Response to Planning Comments

Summary of modifications to proposed scheme in response to planning comments

The following amendments are proposed in response to the comments received on 21.03.2025

Extent of glazing - Comparison between proposed and existing glazing area

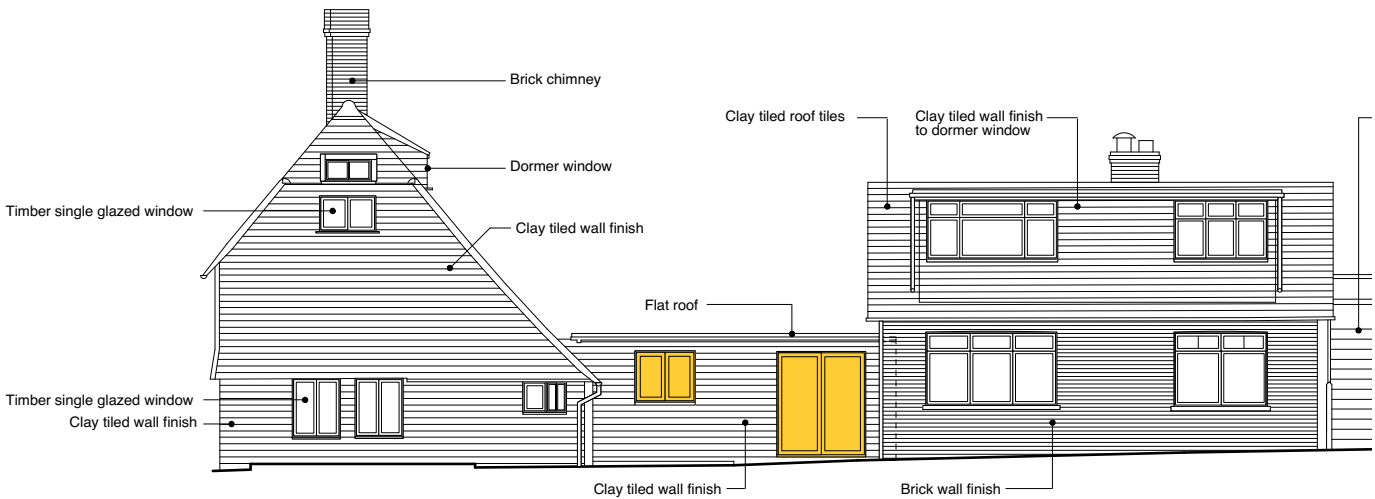
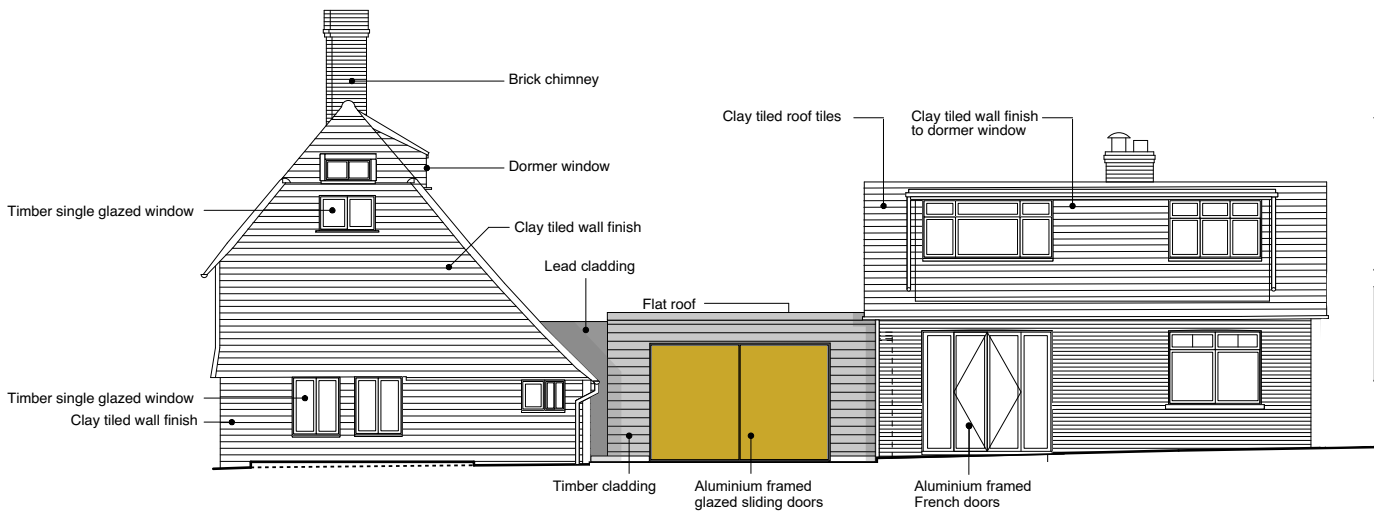
The following diagrams demonstrate the increase in glazing between the proposed scheme and the existing condition along the south elevation.

4.5 sqm (window area)

8sqm (window area)

= 78% increase in glazing

Percieved mass

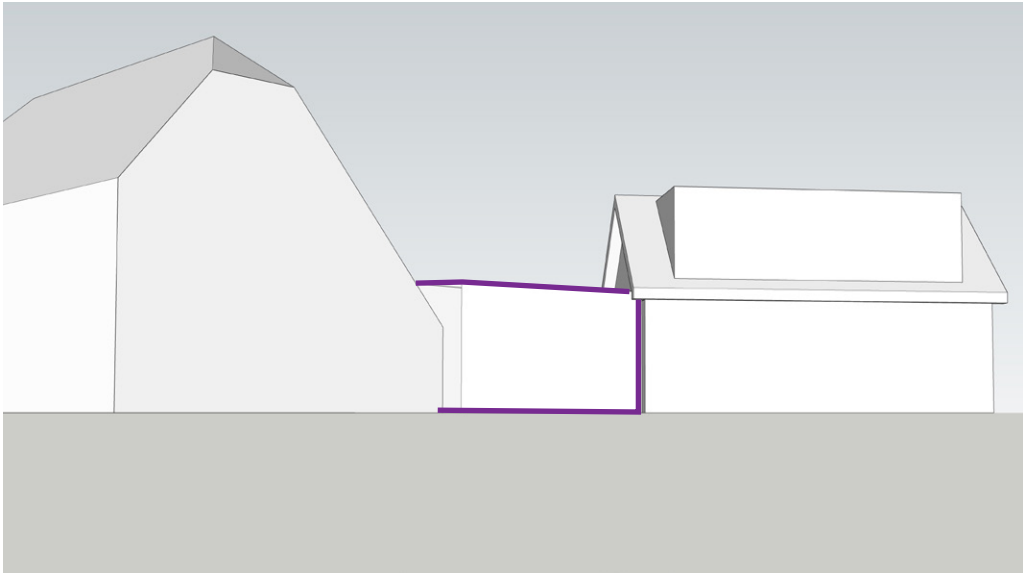
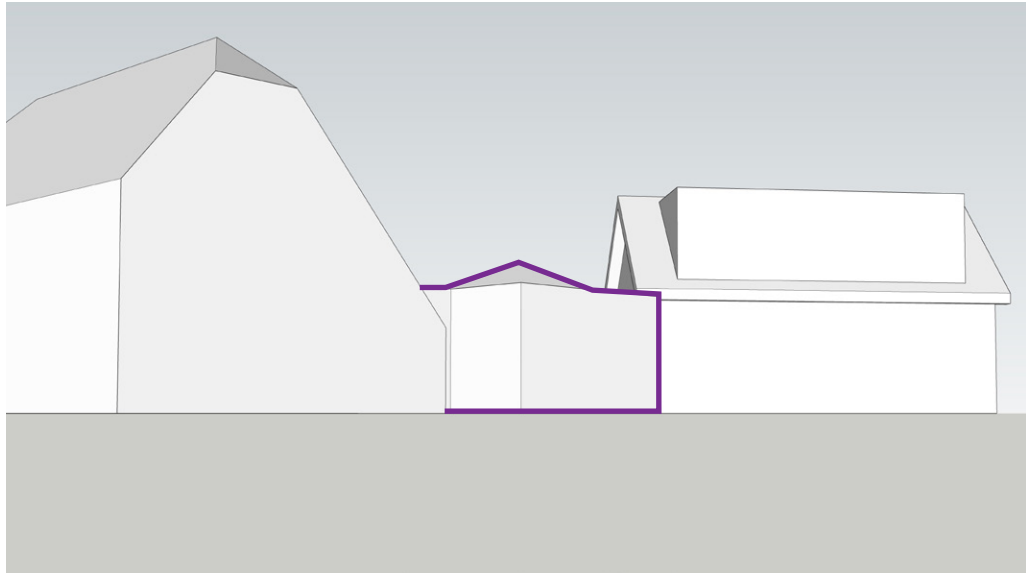
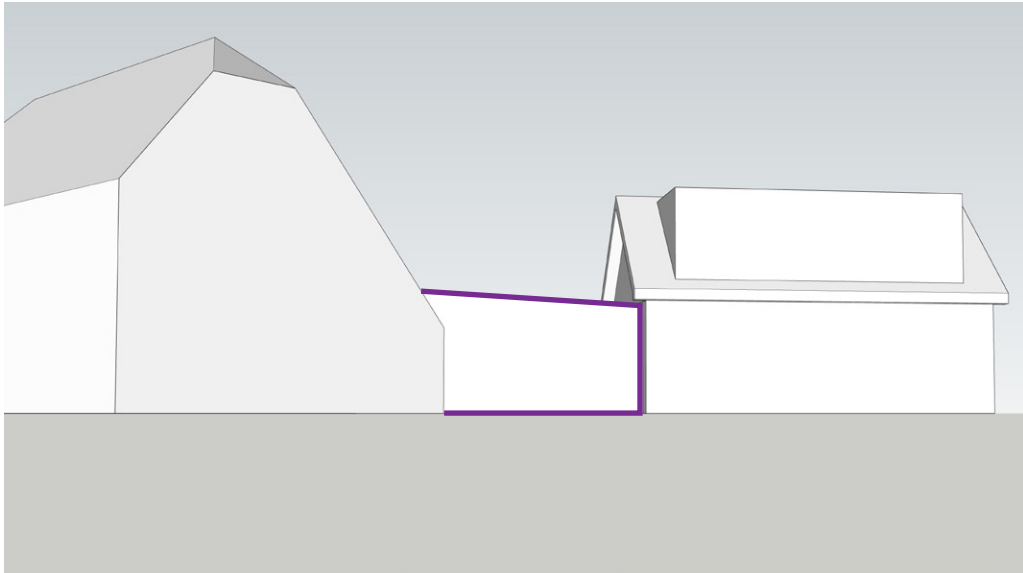
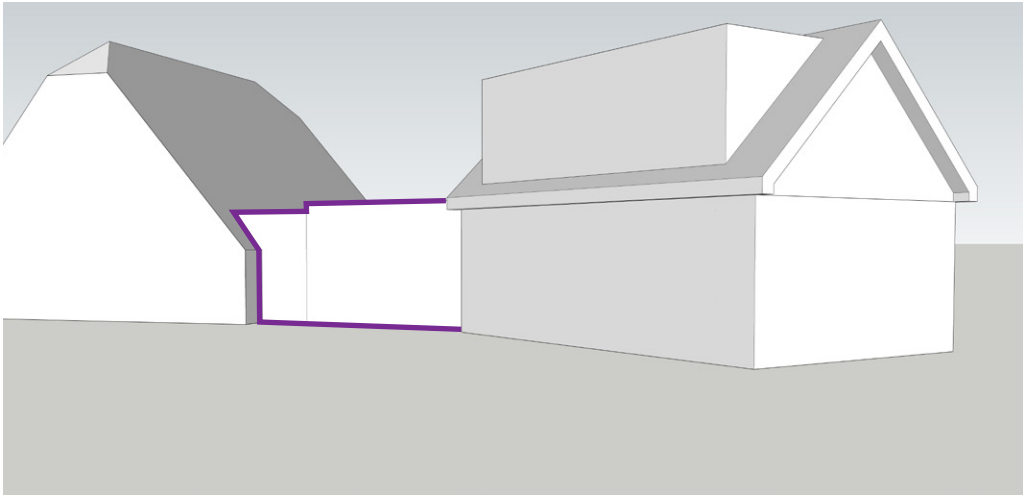
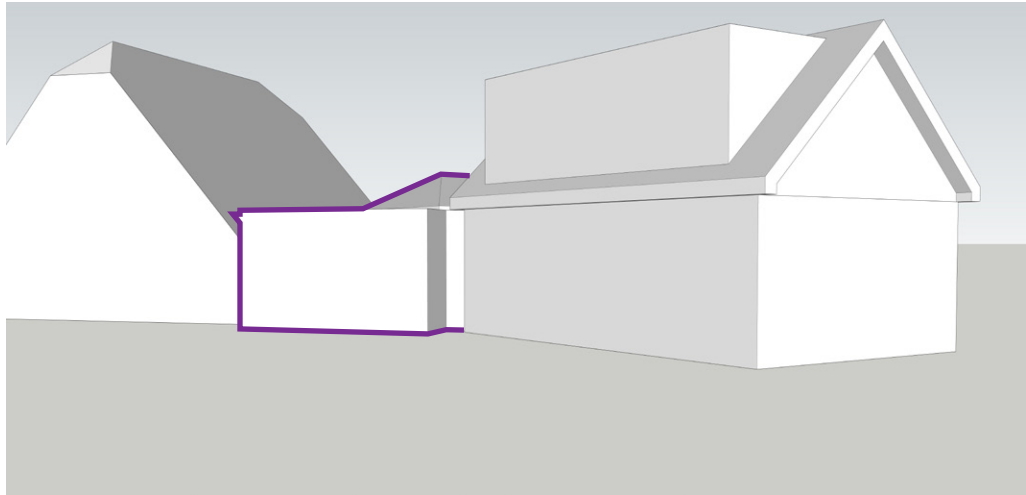
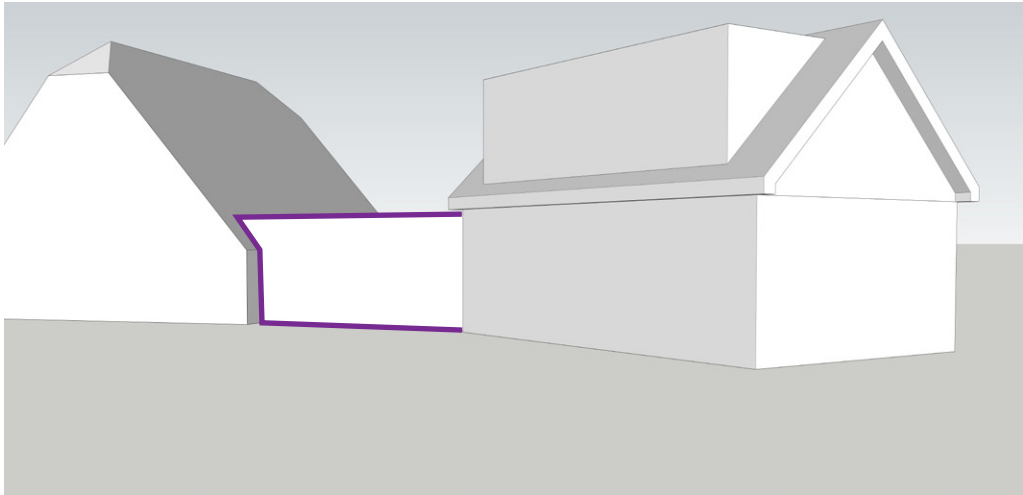
In response to the comments related to perceived bulk and subservience, we offer the following response:

The existing condition is set back from both the cottage and the annexe along the southern elevation thus ensuring the link is recessive and subservient in massing terms. The link is a single story building element, as opposed to the cottage (3 storys) and the annexe (2 story). This further emphasises the subservient perception of the link building.

The approved scheme proposes an increase in height compared to the existing condition, as well as a significant increase in overall mass by projecting southward by 2 meters. This projection brings the link elevation beyond the frontage of both the cottage and annexe buildings - thus diluting its ‘subservience’ significantly.

In addition, the approved scheme includes a large roof lantern that projects 1 meter above the link roof level. This further increases the perceived height and mass of the link when compared to the cottage and annexe.

When viewed from the garden, the projecting form conceals the corners of the cottage and annexe (depending on viewing angle) which increases the dominance of the link and diminishes the prominence and hierarchy of the other two building elements.

The proposed scheme seeks to significantly reduce the massing impact of the approved proposals by setting the link back along its original / existing building line. This ensures it remains firmly ‘behind’ and recessive to both the cottage and annexe.

The proposals do seek to slightly increase the hight of the link from the approved scheme, but this is nominal and appropriate in relation to the floor to ceiling heights and construction build-up requirements stated earlier. The modifications to the proposed scheme now show a step in the parapet at the point of connection with the cottage to help mitigate this impact and align with the approved scheme.

The recessive massing allows the corners of the cottage and annexe building to remain legible regardless of viewing aspect and reinforces the hierarchy of the three building elements.

The proposals also seek to reduce the roof lantern to a low-profile roof light that is not visible above the parapet line, ensuring the mass of the link is as simple and restrained as possible, further supporting the overall composition and clarity of the property as a whole.

Installed french doors (with aluminium framing and dark grey PPC finish)

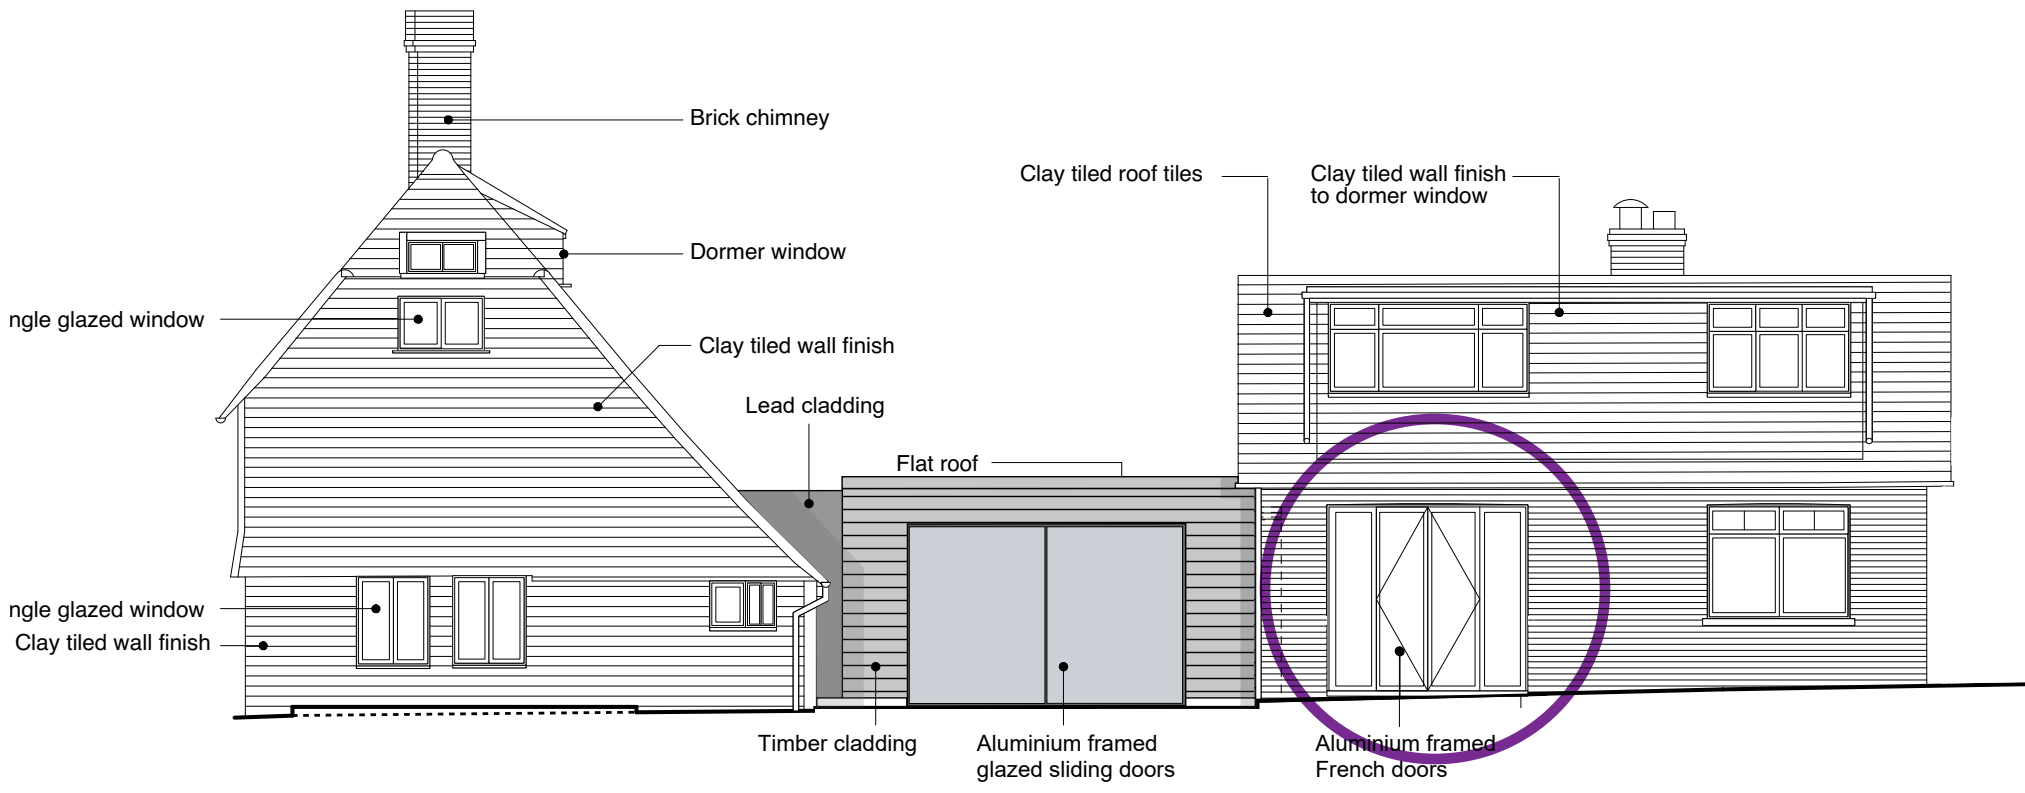
- The proposed changes to the form and footprint of the link extension remove the approved projection into the garden to the south of the house, so that the building line will be similar to the existing. This is not considered contentious in principle, however the height of the replacement link has increased so that it now sits above rather than below the eaves of the annexe building and rises higher up the catslide roof to the rear of the original building. This is not considered acceptable due to the adverse impact on the subservience of the link to the cottage and annexe, as well as the fabric of the catslide, and should be reconsidered. Furthermore proposed changes to the elevation to introduce more solidity will add to the apparent bulk of the link as well as reducing the extent to which it allows a visual separation between the house and the bulk of the annexe. **The use of aluminium framed windows in place of timber framed also does not relate well to the context. I would also suggest that this should be reconsidered.**

In response to the appropriateness of the proposed aluminium finish to the new windows and doors we offer the following response:

1. The use of aluminium framing to windows and doors was previously approved as part of the previous application's conditions discharge process - Condition 3. See attached the drawing sheet issued and approved.
2. The French doors to the south elevation of the annexe which were approved as part of the previous application have been subsequently installed as aluminium framed with a dark grey PPC finish.
3. Our proposals seek to match this aesthetic to compliment the French doors and to ensure consistency of finish to the more recent additions to the property - as previously approved
4. As per the Design and Access statement, we are proposing composite windoes and doors, which have an aluminium finish externally but a treated timber finish internally.
